MORGANTOWN PLANNING COMMISSION

STAFF REPORT

CASE NO: S15-11-III / Feoh Realty, LLC / Donahue Drive

PLANNING AND ZONING CODE CONFORMITY REPORT FOR PLANS DATED 06 NOV 2015

E902
 Scale 1" = 30'-0"
 SCALE REFERS TO 22" X 34" PAPER SIZE

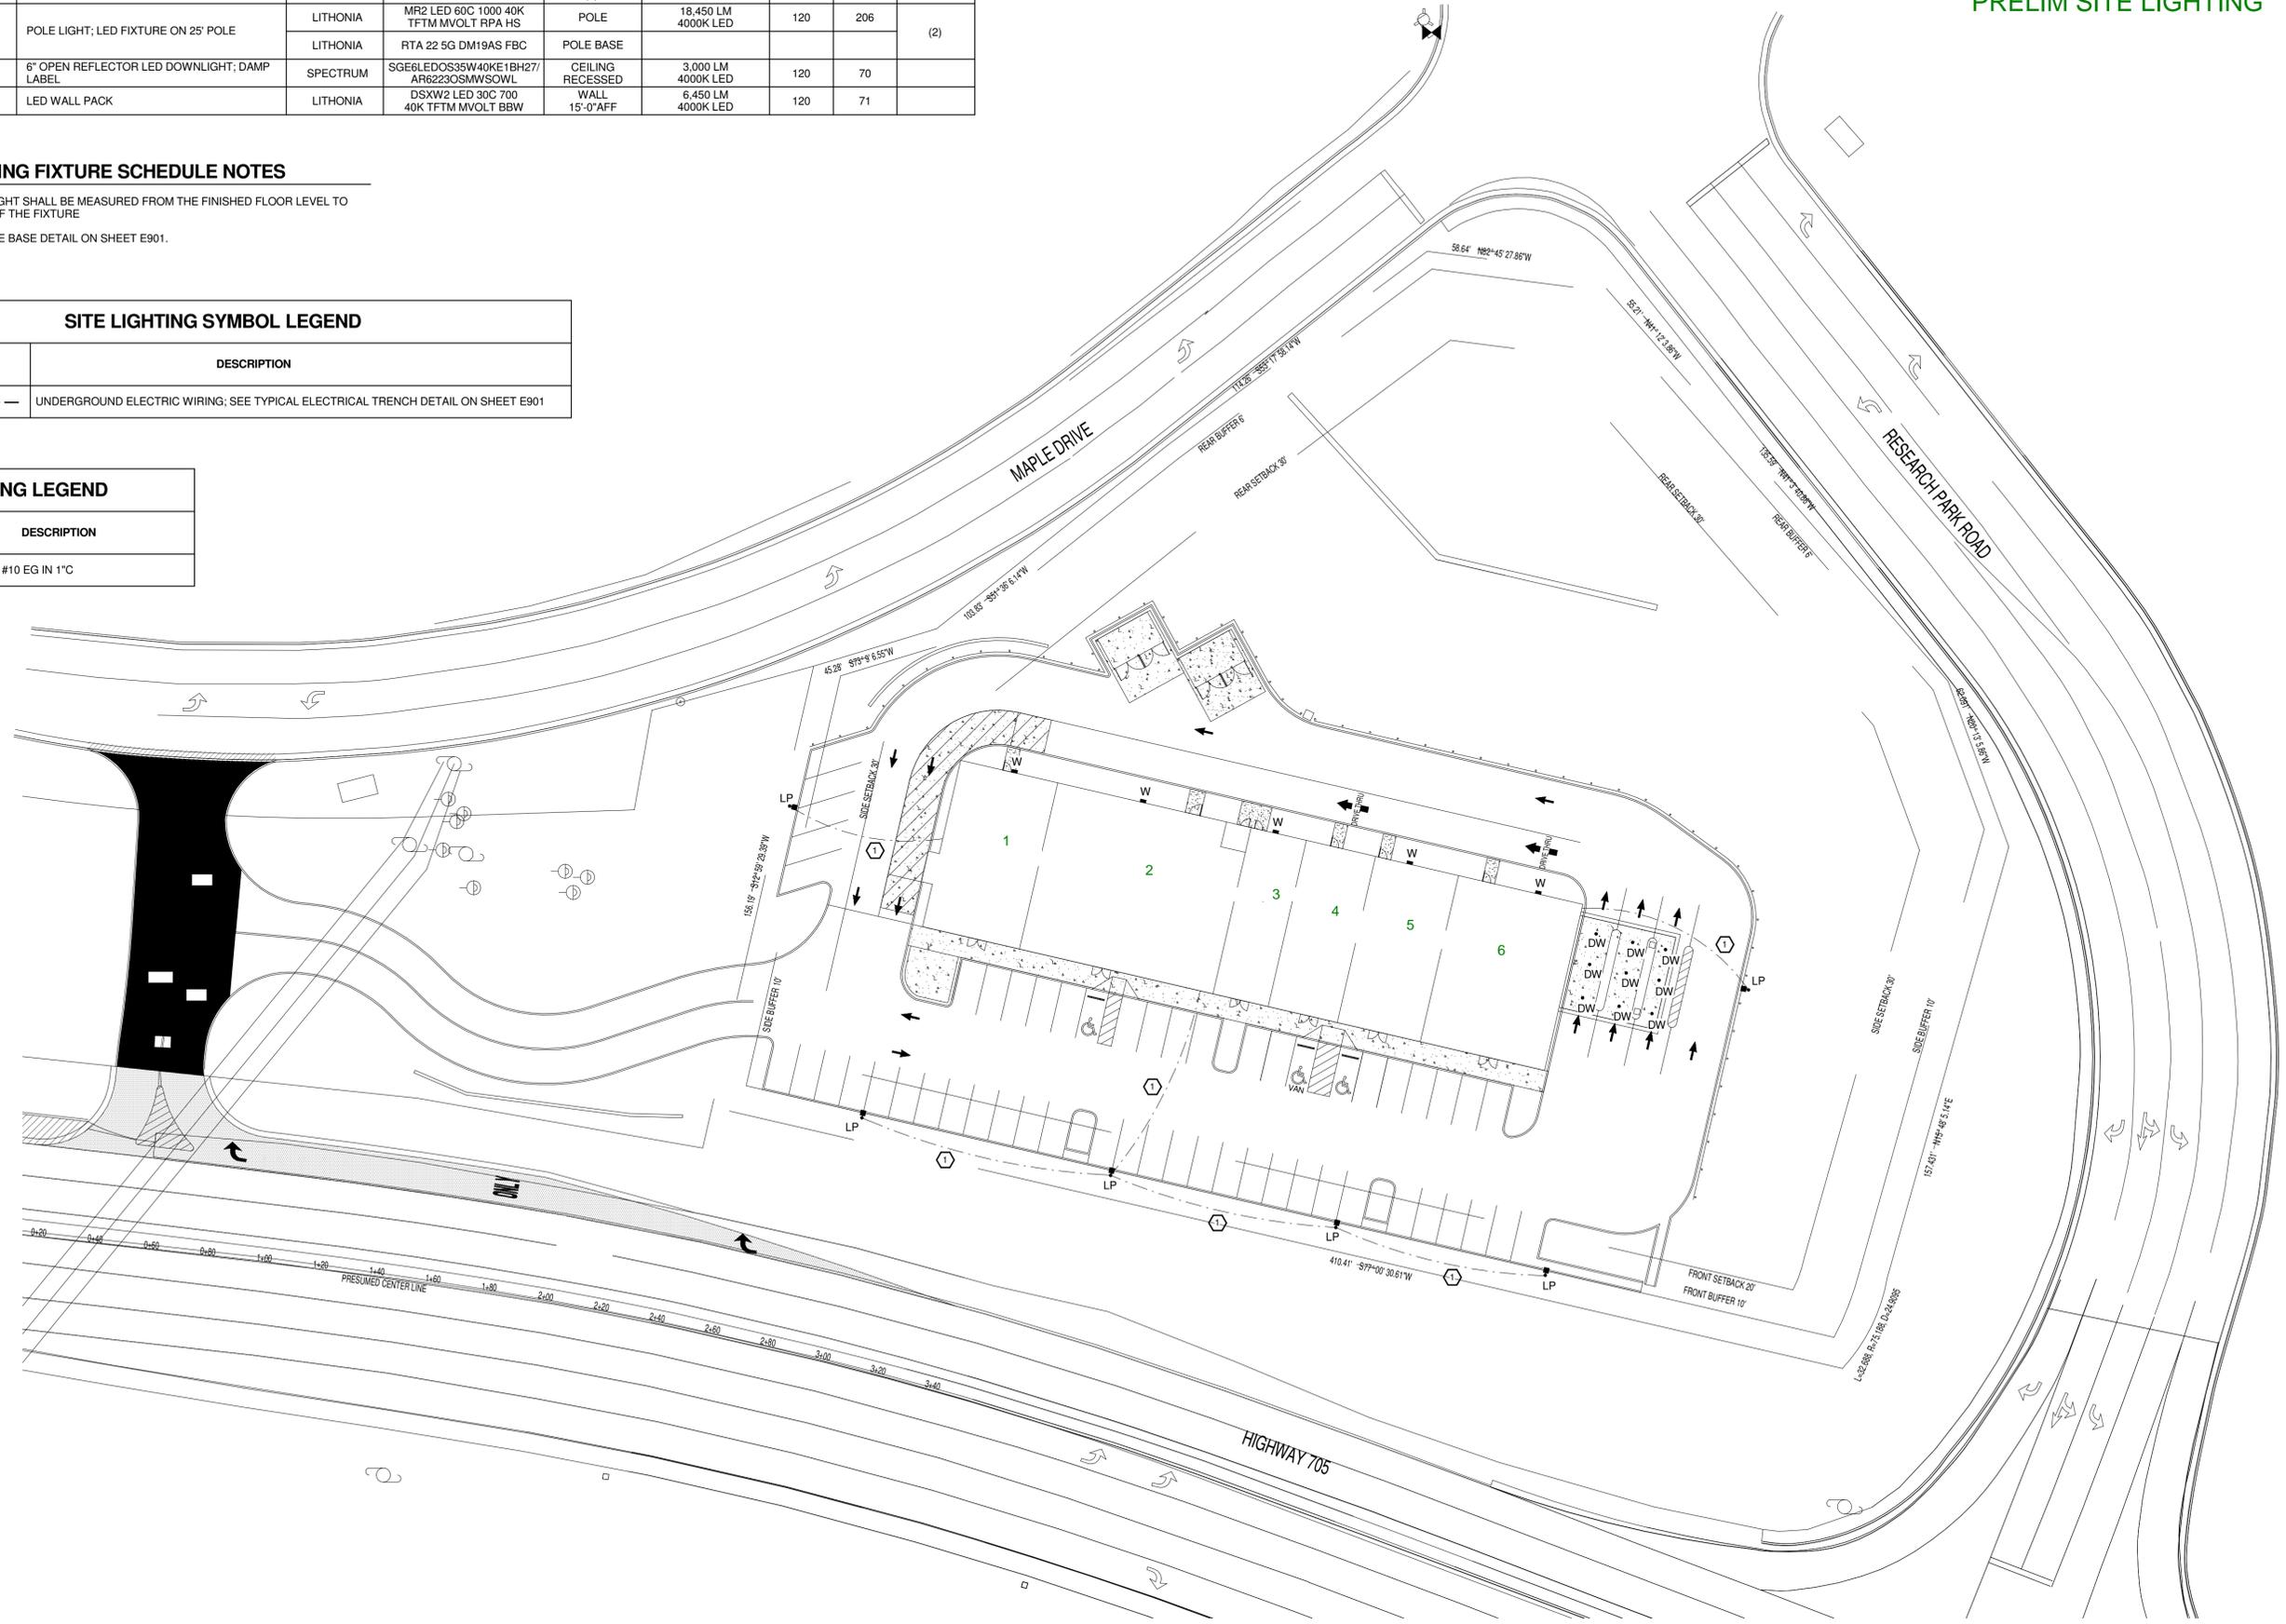
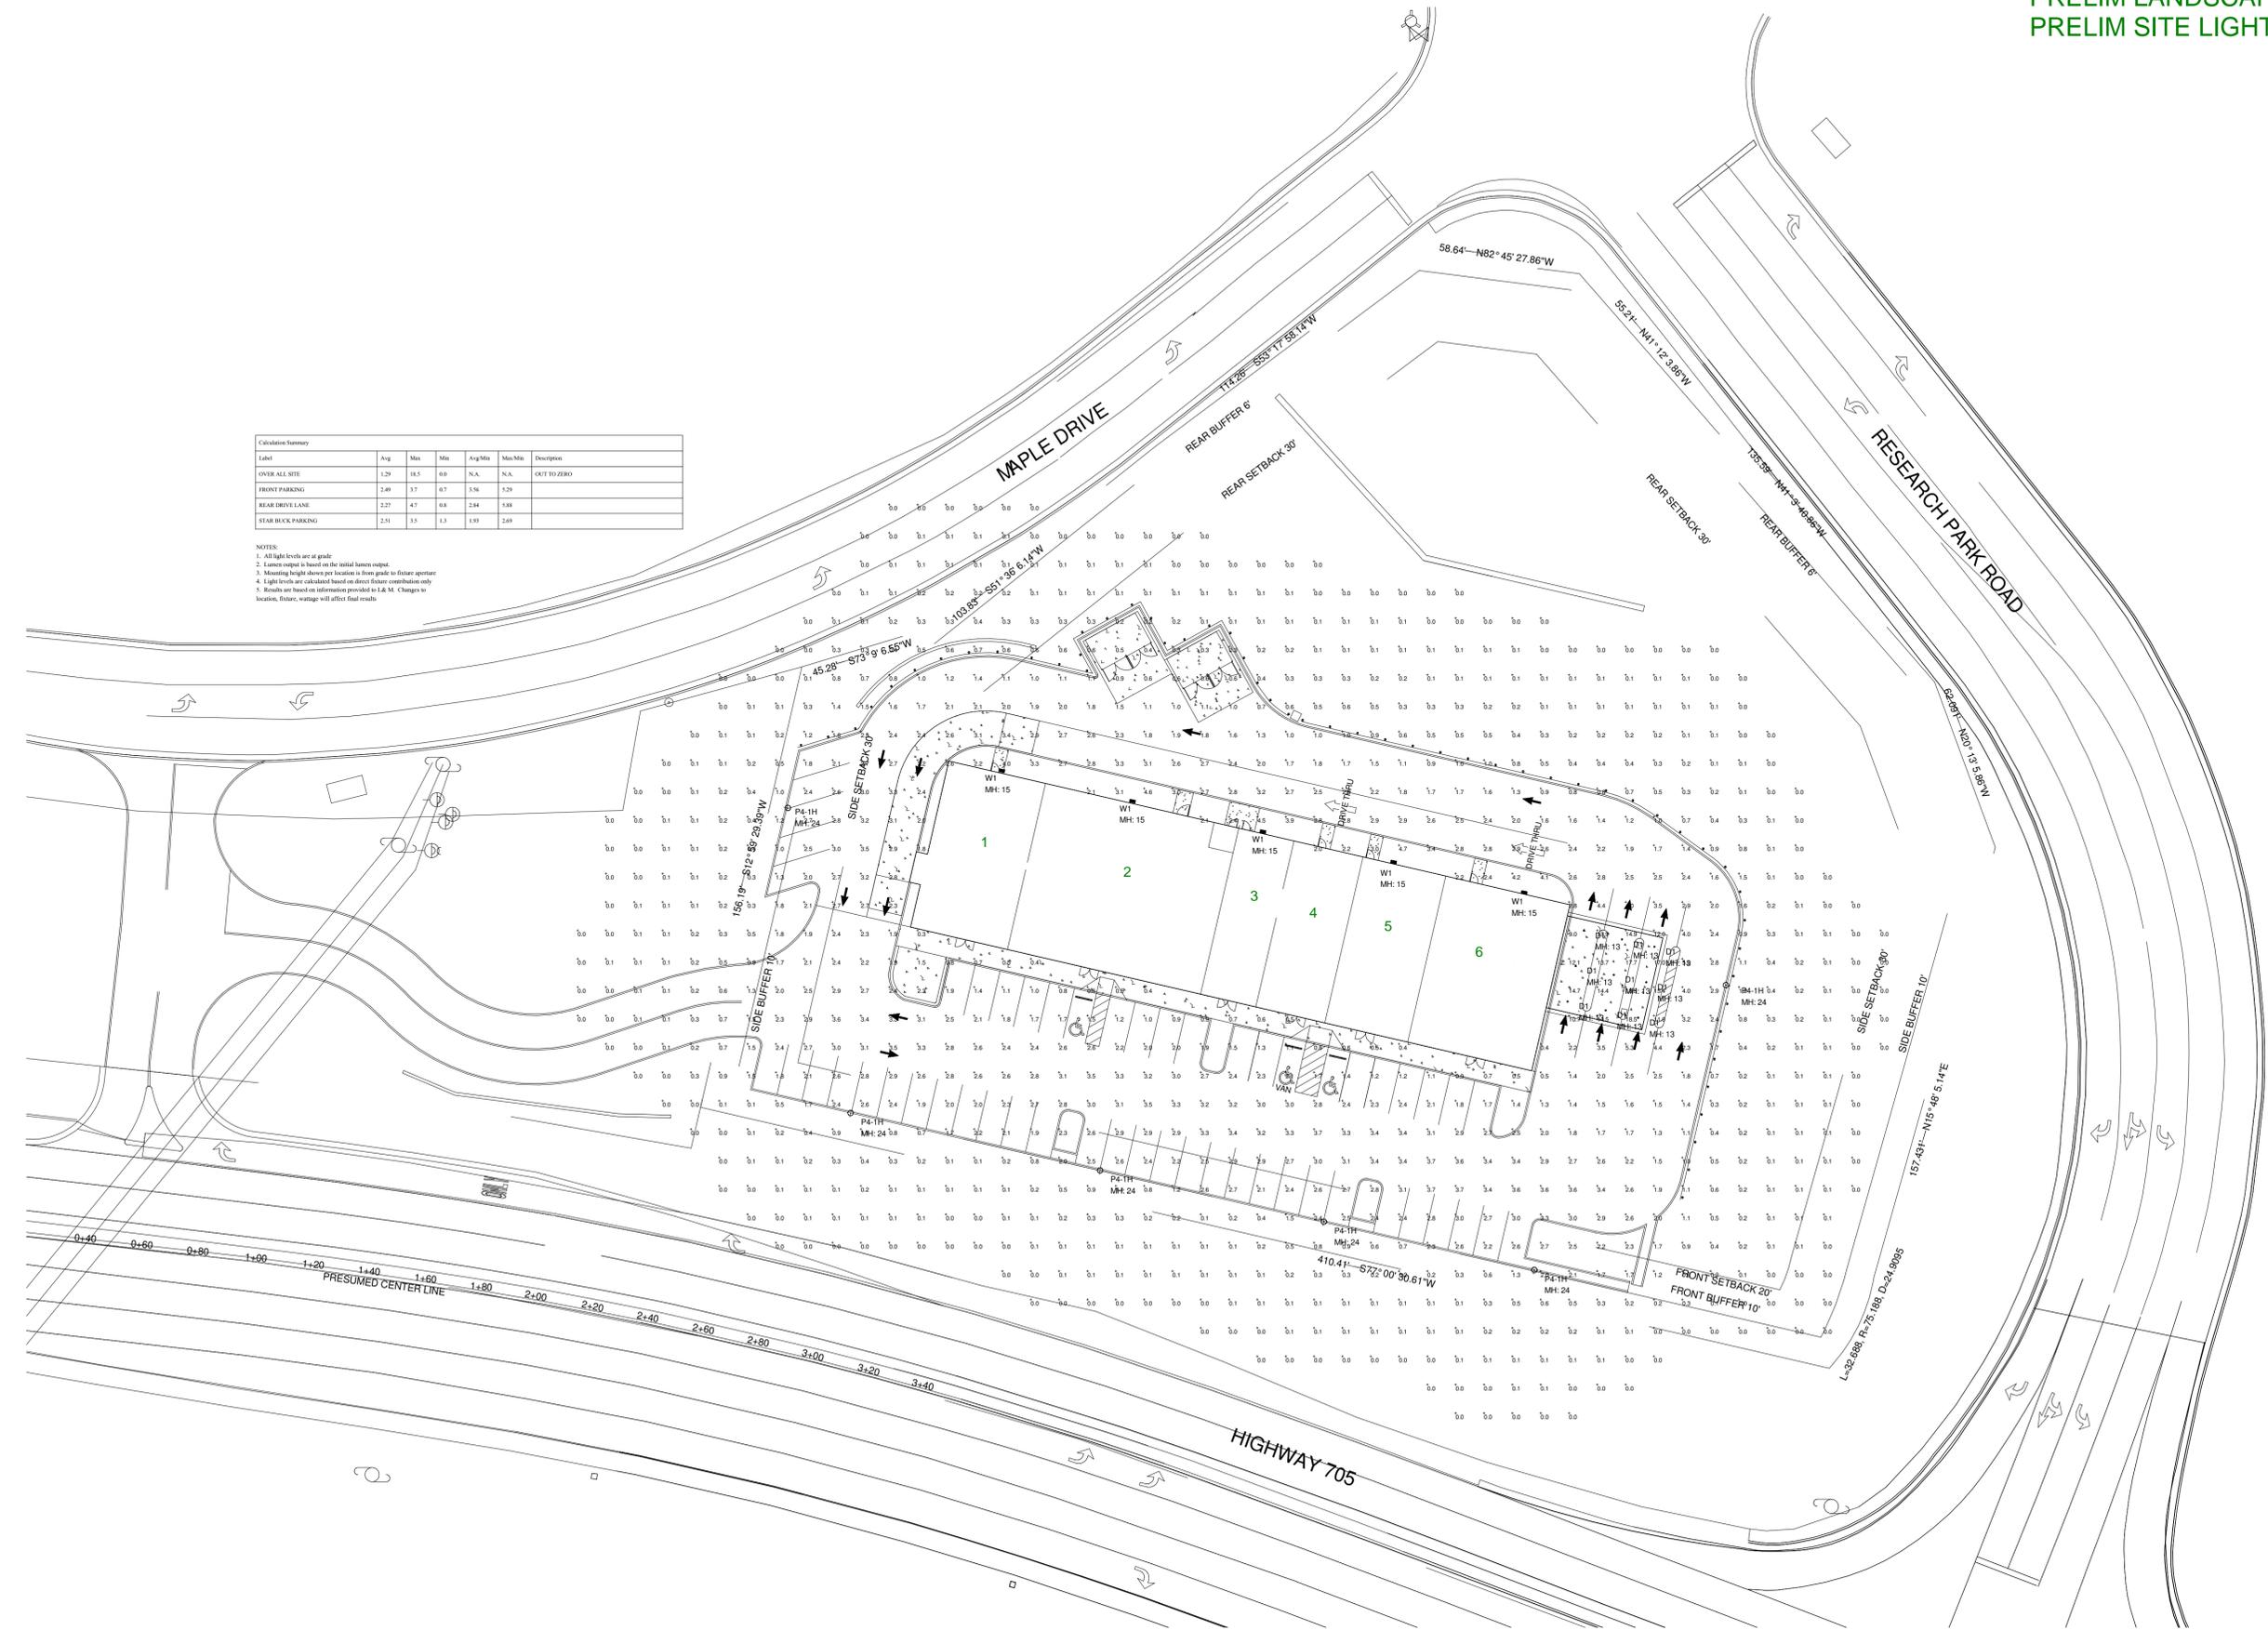
TBD	<p>(B)(6) Layout and Design – Landscaping and screening. <i>SEE OBSERVATIONS UNDER ARTICLE 1367 BELOW.</i></p>
Y	<p>(B)(7) Layout and Design – Lighting. <i>The Preliminary Lighting Plan provided on Sheet 4 Drawing E902 appears to observe the glare restrictions of this provision. See Article 1371 observations for additional comments.</i></p>
Y	<p>(C)(1) Surfacing. <i>“Standard Duty Pavement” and “Heavy Duty Concrete” are noted on Sheet 3 Drawing 9. Paving design along with stormwater management will be reviewed and approved by the City Engineer and Morgantown Utility Board (MUB) at building permit application.</i></p>
N/A	<p>(C)(2) Gravel surface. <i>Gravel surfacing is not proposed in plans reviewed herein.</i></p>

TBD	<i>The Preliminary Lighting Plan on Sheet 4 Drawings E900 – E902 appears to provide sufficient lighting for the parking areas without unnecessary glare onto adjoining properties or public rights-of-way. The final Lighting Plan, including light fixtures and lighting intensities, will be reviewed during building permit application.</i>
-----	-------------------------------------------------------------------------------------------------------------------------------------------------------------------------------------------------------------------------------------------------------------------------------------------------------------------------------------------------
